# Rezoning Transportation Analysis

Petition Number: 2018-150

## Revision Log:

Date	Description
12-20-2018	First Review
<del>01-23-2019</del>	Second Review—Note No Revised Site Plan Submitted to City/CDOT
09-24-2019	Second Review

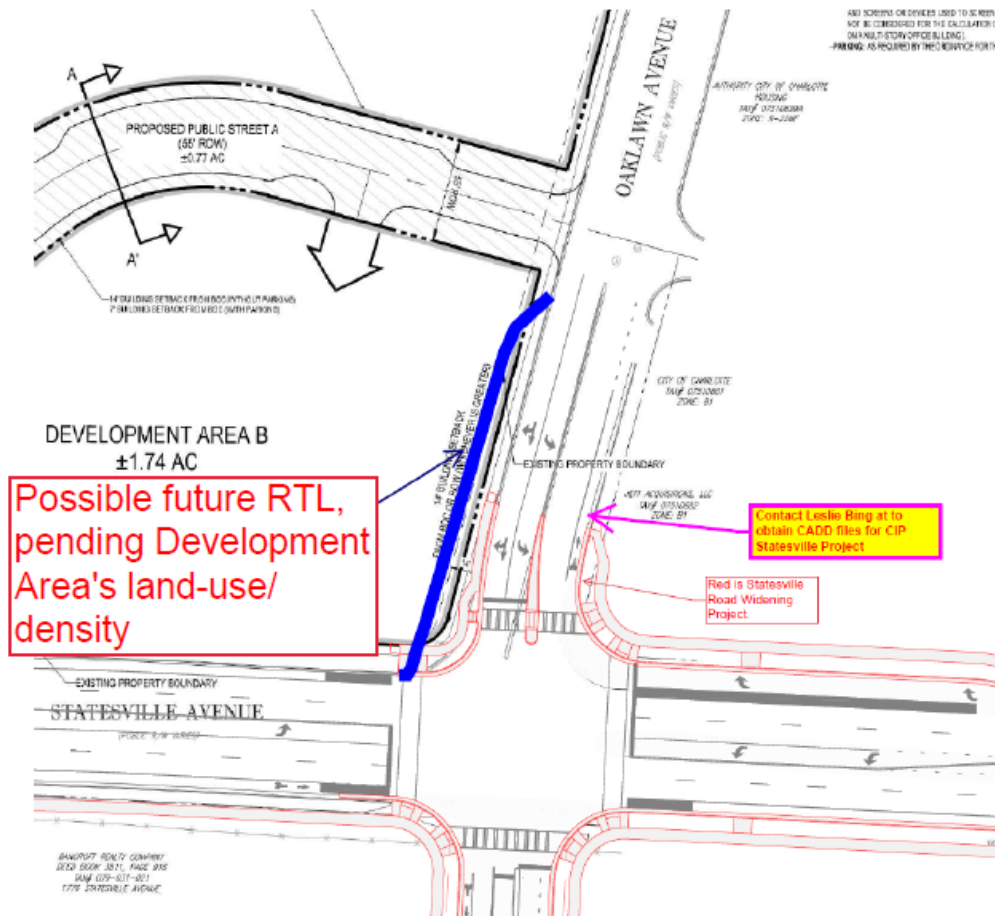
- The petitioner needs to revise the site plan and conditional notes to provide and commit to implement a pedestrian refuge island and accessible ramps on each side of Oaklawn Ave., south of Spring Street (see below construction plans).
